BENDIX STREET

NON-MATERIAL AMENDMENT REPORT

D480-TGA-RP-FL_90_72-0001

16.02.23 - ISSUE 1

4.1 BENDIX STREET ELEVATION & GROUND FLOOR PLAN

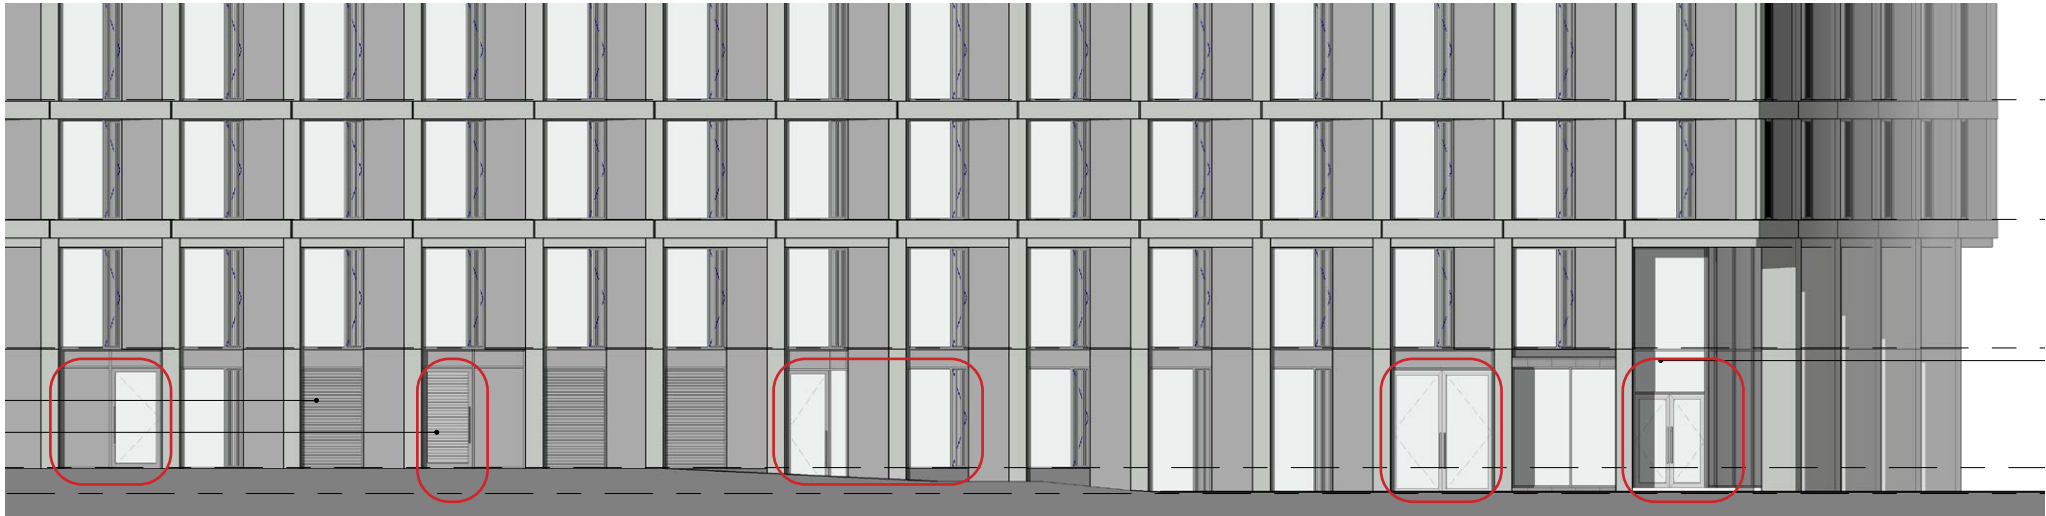
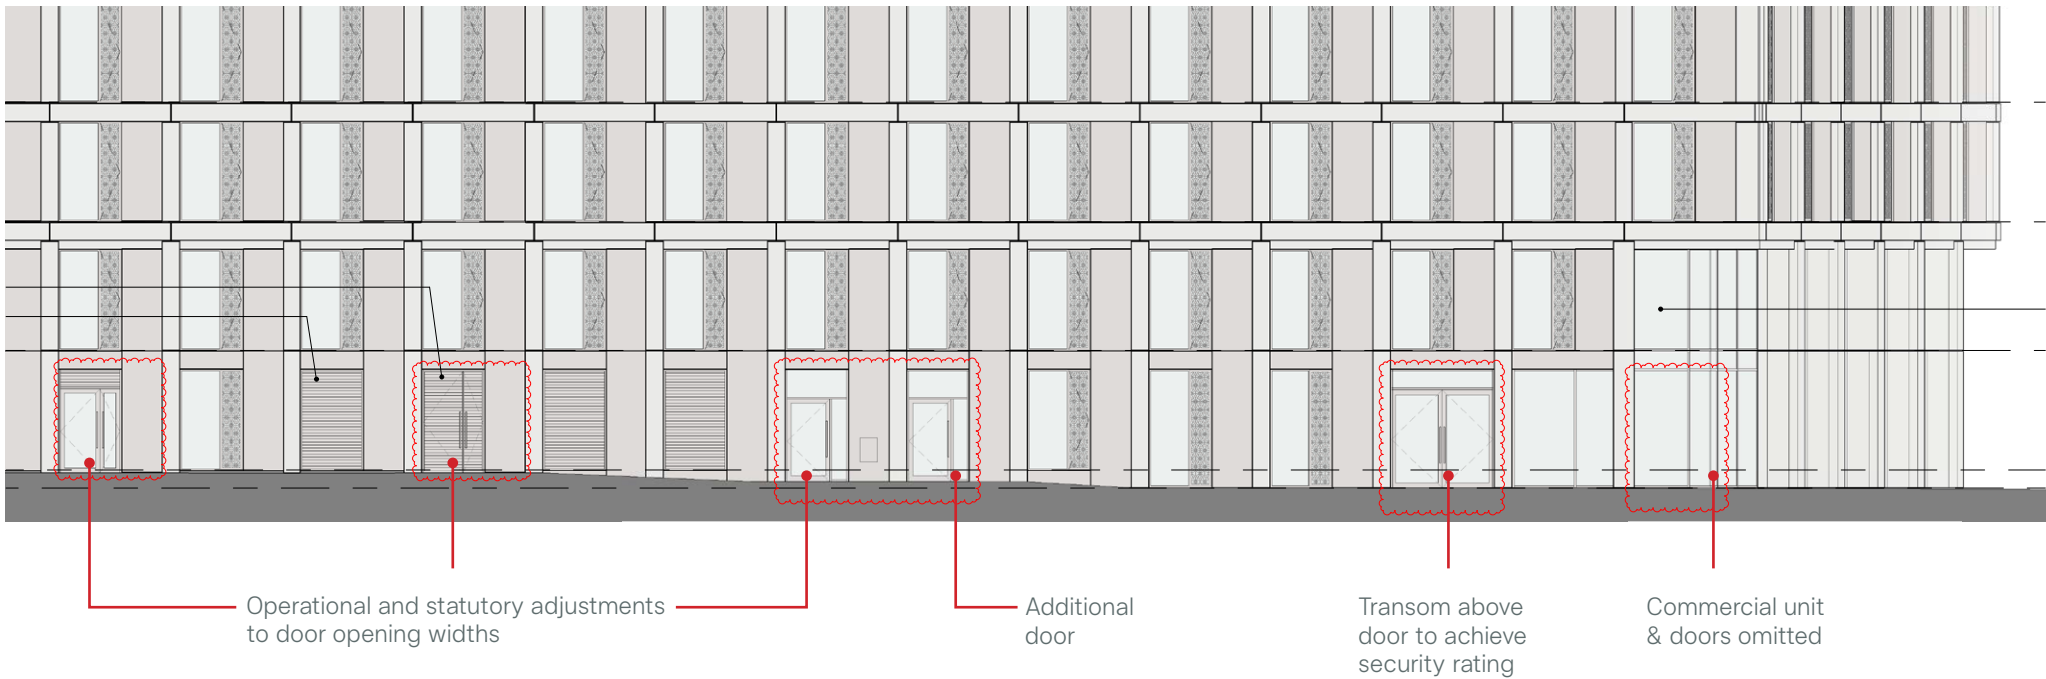
- The proposed adjustments to ground floor doors below are indicated on the drawings:
- The commercial unit and associated entrance doors are omitted
 - Full height glazed doors require a fixed glazed pane above door head, to achieve security rating
 - An additional access door is added on Bendix Street, access will be controlled and for management only
 - Some back-of house doors have been adjusted to suit various operational and statutory requirements for door widths

4.2 THOMPSON STREET ELEVATION & GROUND FLOOR PLAN

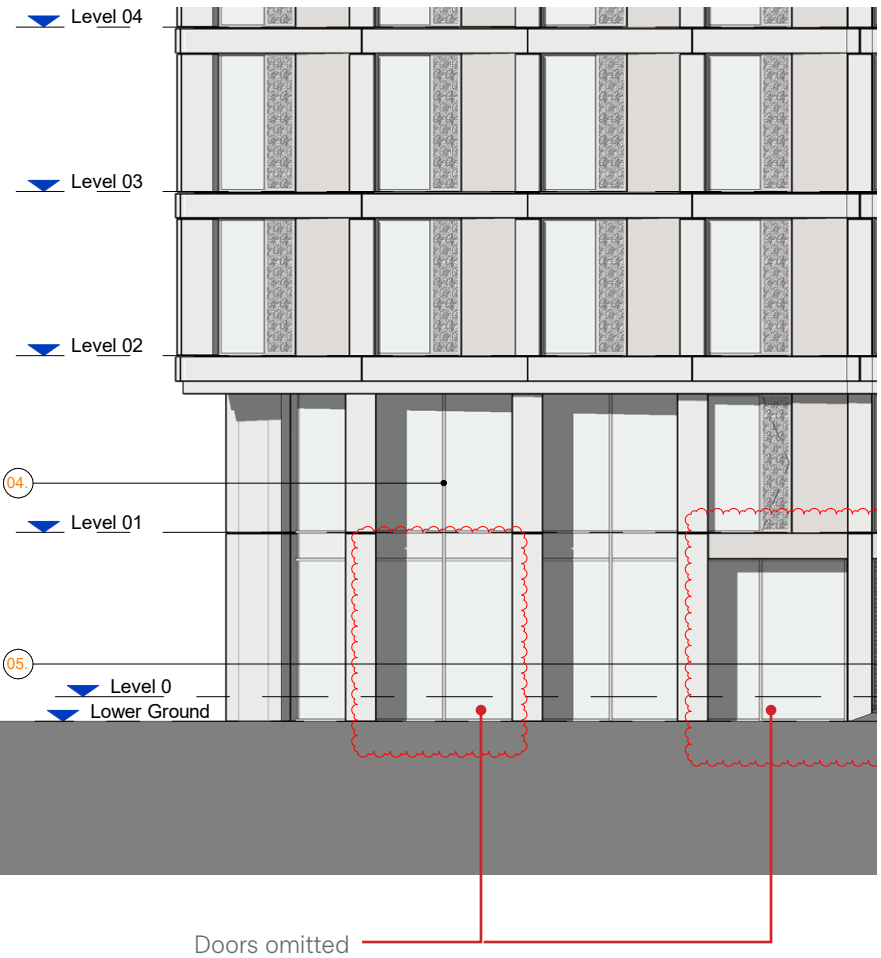
The Commercial unit being reallocated as residents' amenity means associated access doors are omitted from Bendix Street and Thompson Street elevations.

- Glazed entrance door omitted
- Commercial unit's store and associated door omitted

5.1 GATES TO JUNCTION WITH THOMPSON & BENDIX STREET

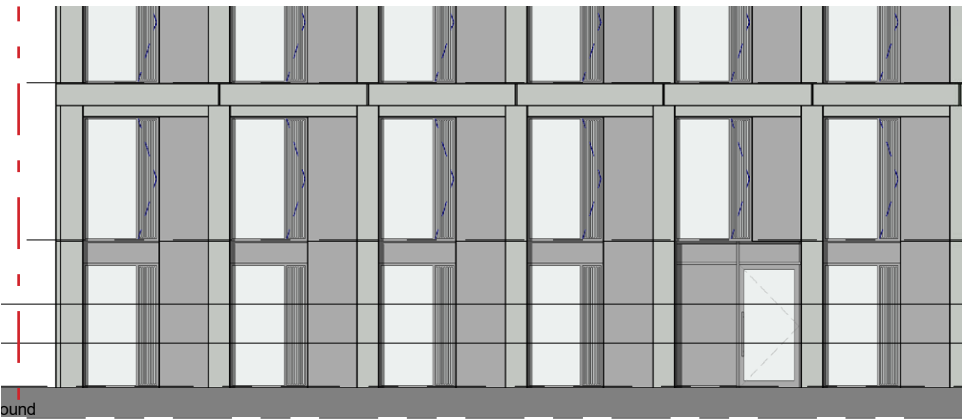
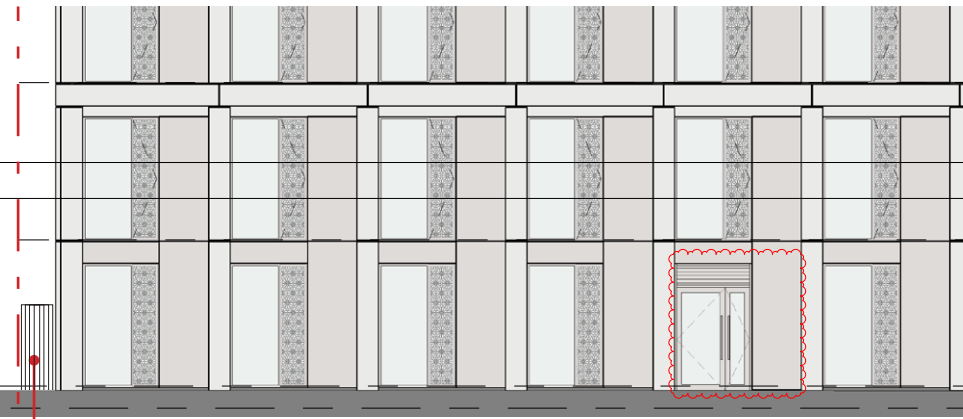
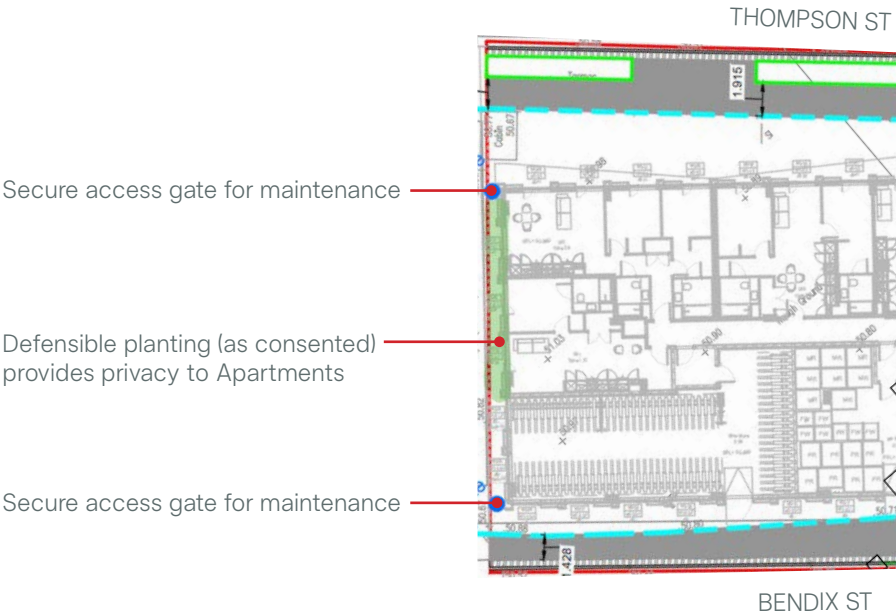
During the development of the Section 278 Highways design works, concern was raised regarding access and security of the 'rear' (north-western) elevation, facing the Smithfield Project and car park.

The ground floor plan extract below shows a highlighted green strip (circa 1 metre wide) currently designed with defensive planting to keep pedestrians away from the habitable windows.

Concerns were raised about this pedestrian walkway through from Bendix Street to Thompson Street at the 'rear' of the building becoming a hot-spot for anti-social behaviour. It is therefore proposed to install a secure pedestrian gate at either end of the walkway, to restrict access to this zone Thompson and Bendix Street only for maintenance.

GMP (Design for Security department) have been consulted on this proposal, and have confirmed their support.

Gate to be added, as supported by Design for Security (GMP)

6.1 GROUND FLOOR SUBSTATION (THOMPSON ST ELEVATION)

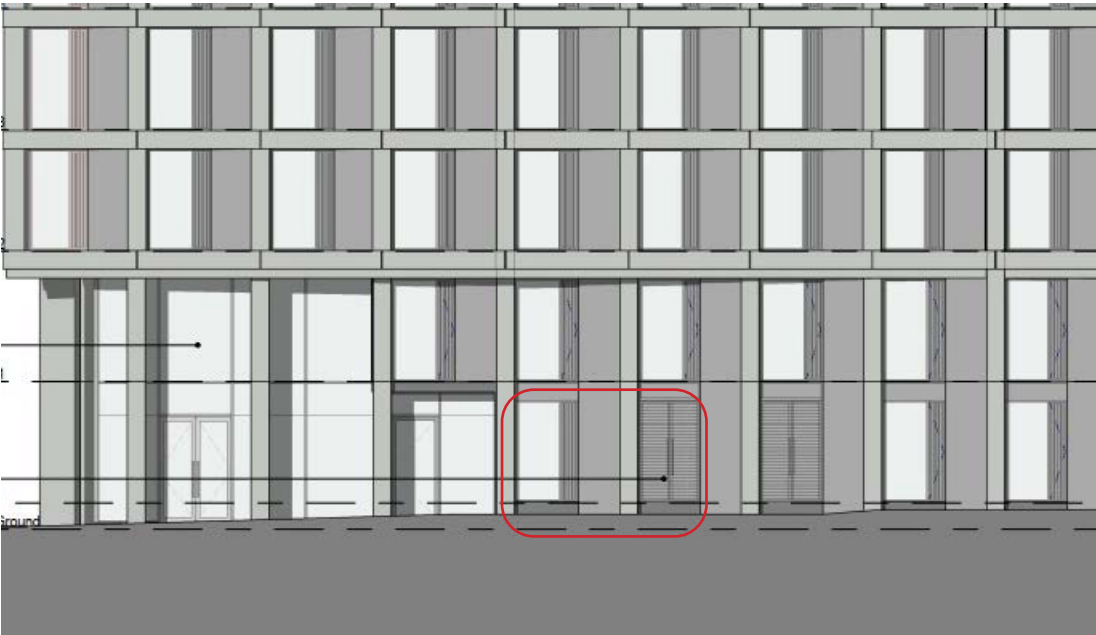
The proposed rooftop plant room would house electric-powered heating equipment and hot water vessels.

This alternative servicing strategy means the building's heating and hot water could use an all-electric supply, with the potential to be free from fossil fuel-based energy sources.

A new substation would be required at ground floor level to handle the associated increase in electricity demand.

Louvre replaced with wider Substation door

Narrow door replaced with louvre

Note: Generic louvred door shown indicatively.
Detailed design will need to meet requirements
of utility provider / statutory undertaker

6.2 ROOFTOP PLANT ROOM (ROOF PLAN)

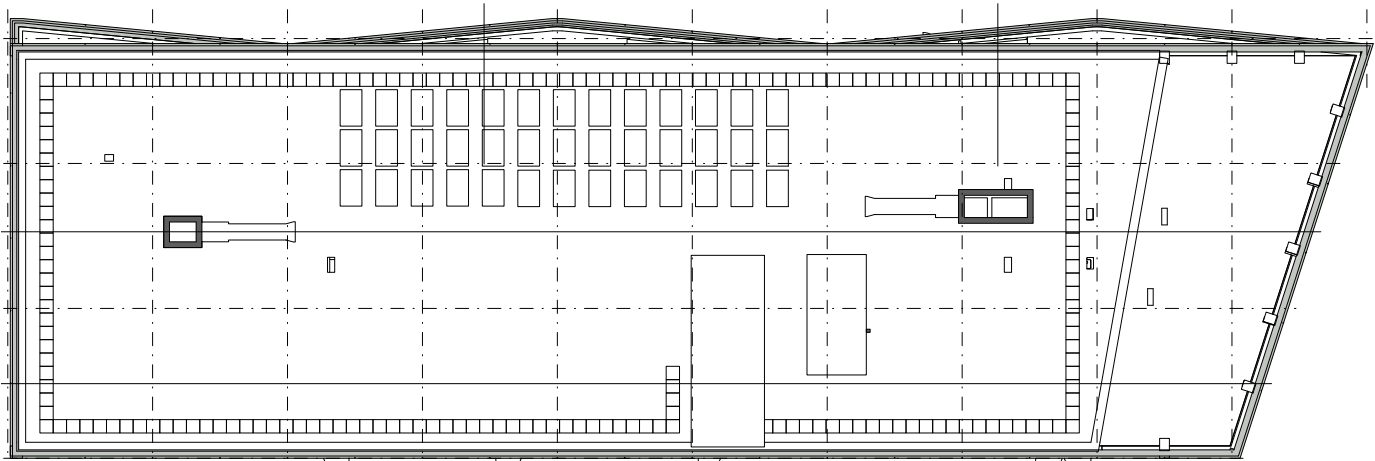
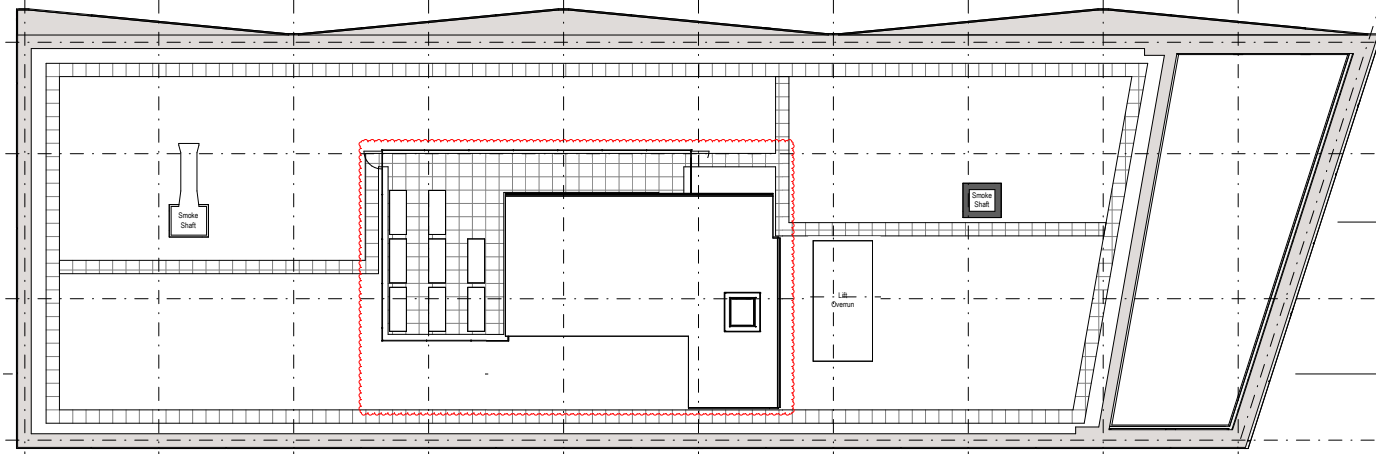
The proposed rooftop plant room would house electric-powered heating equipment and hot water vessels.

Plant is currently located at ground floor, and no additional space is available in the building, hence the need to house plant equipment in a new enclosure on the roof.

Predicted in-use carbon emissions show a reduction when compared to the previous proposal (gas powered), as modelled by the energy consultant.

6.3 ROOFTOP PLANT ROOM - MINIMISING VISUAL IMPACT

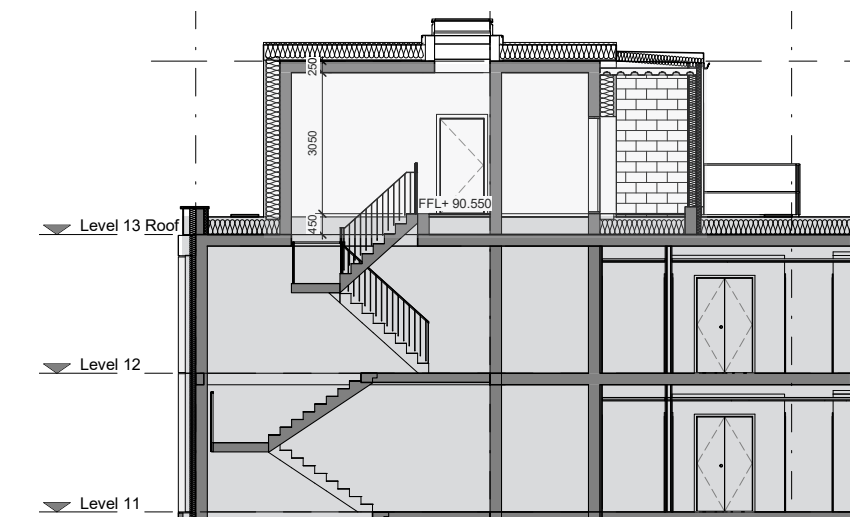
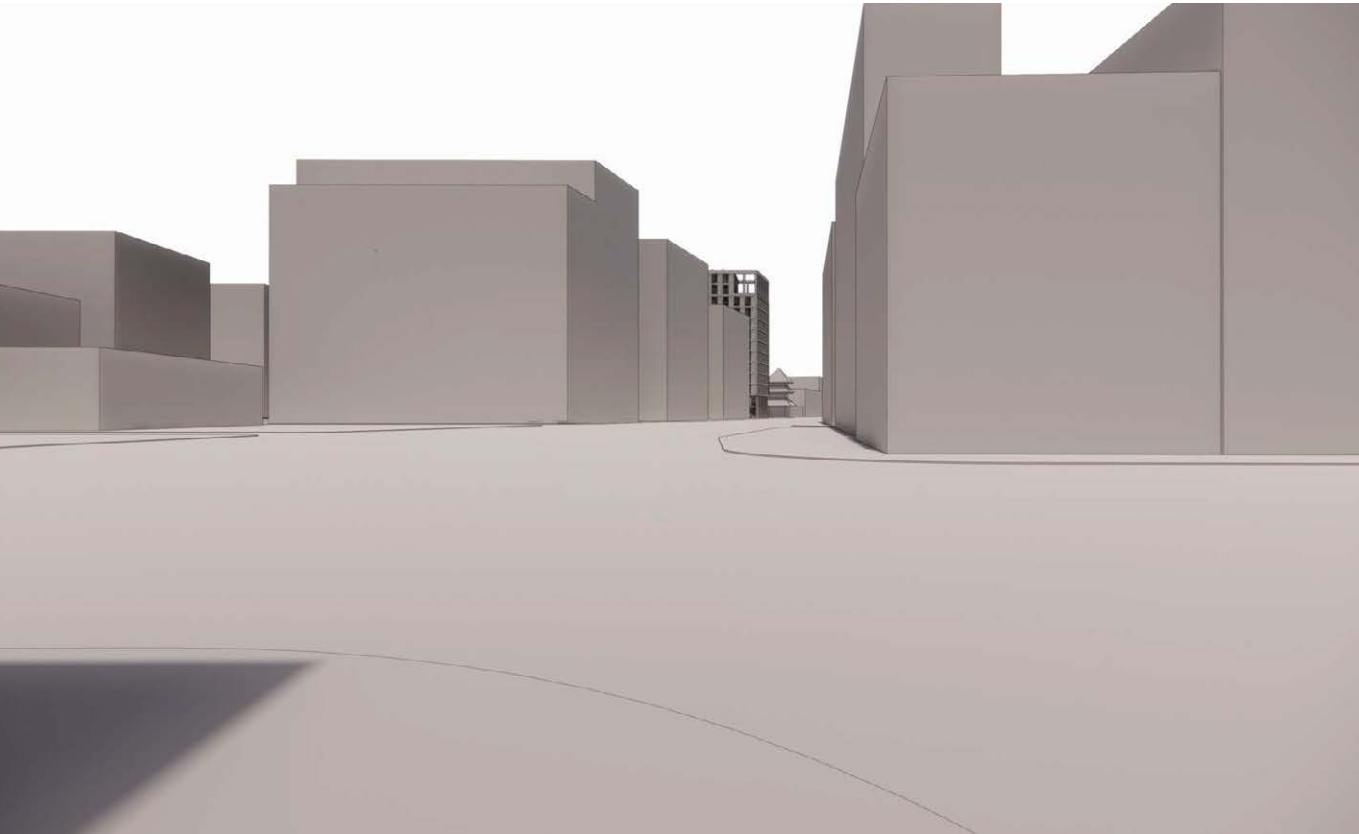
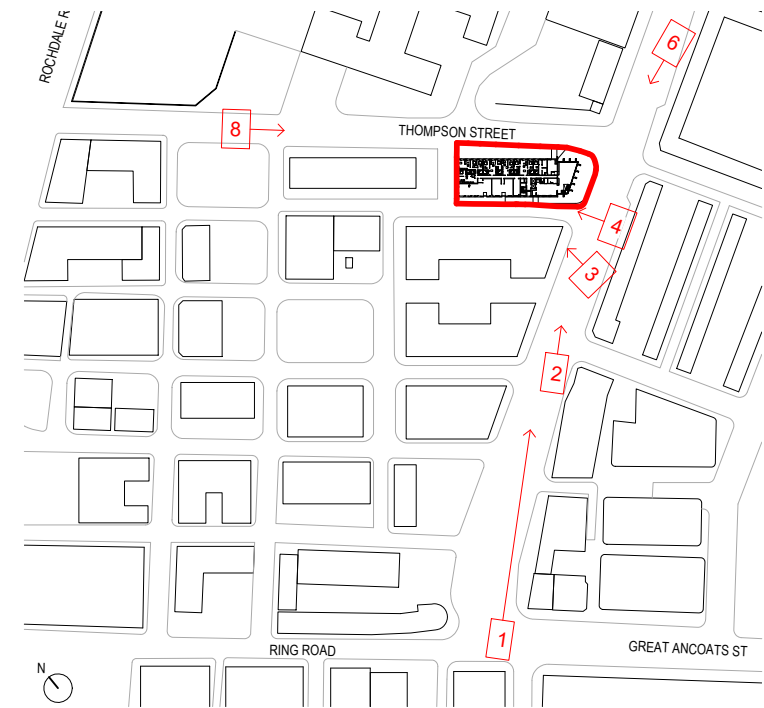
The form and external materials have been developed to reduce the plant room's visibility from the street and from afar:

- 1. The walls of the rooftop plant room are stepped back from the main building's external walls
- 2. Height is kept as low as possible, and plant is centred on the roof
- 3. Proposed external materials are designed to avoid drawing attention to the rooftop plant room

1. Walls stepped back from edge

Health and Safety best practice recommends a stair to serve highest level, rather than a ladder or hatch.

The stair core has been stepped back to reduce the visible impact from street level, as seen in the views on the following pages.

2. Plant room height minimised and centred on building

Height kept to a minimum to reduce visibility

Central location on the building helps give a more balanced composition overall

3. External material proposals

A pale grey cladding is proposed to reduce the visual impact of the rooftop plant enclosure, and help it to be less visible and to blend in with the sky.

ELEVATIONS - OLDHAM ROAD

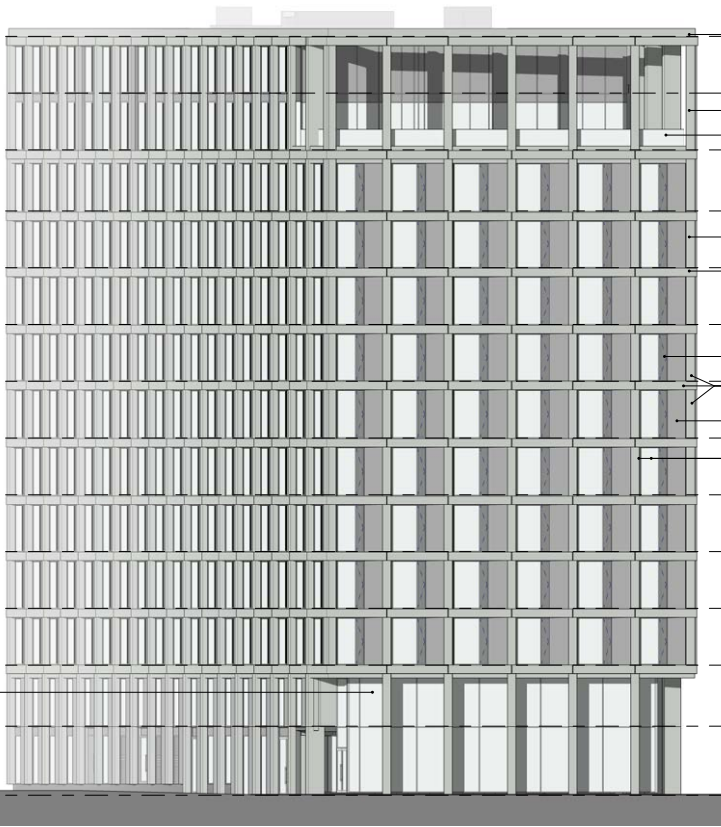
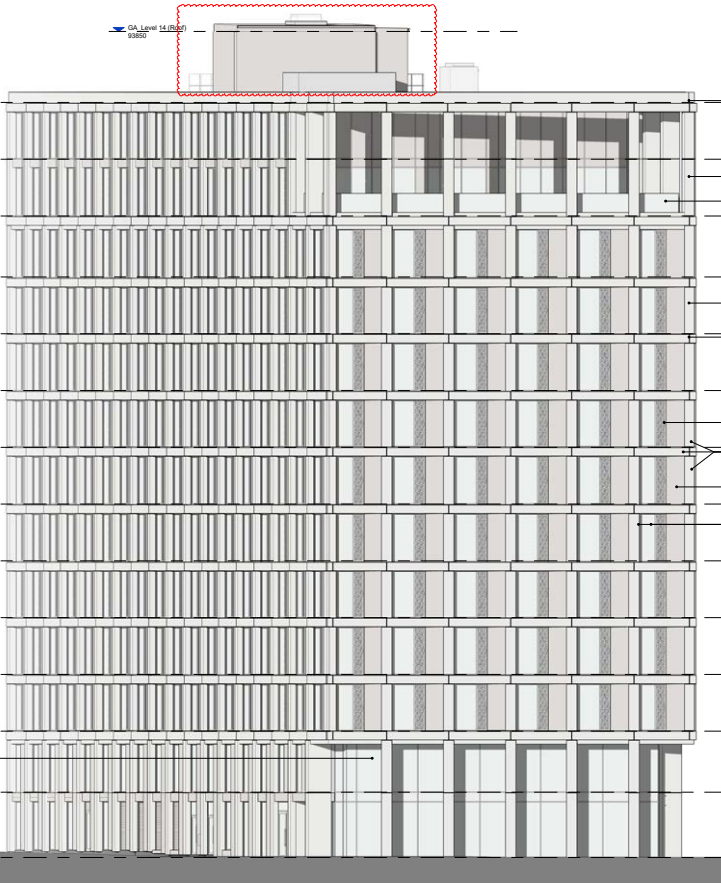
- Proposed alterations to Oldham Road elevation;
- Rooftop plant developed at detailed design
 - Window perforated pattern & soffit trim developed
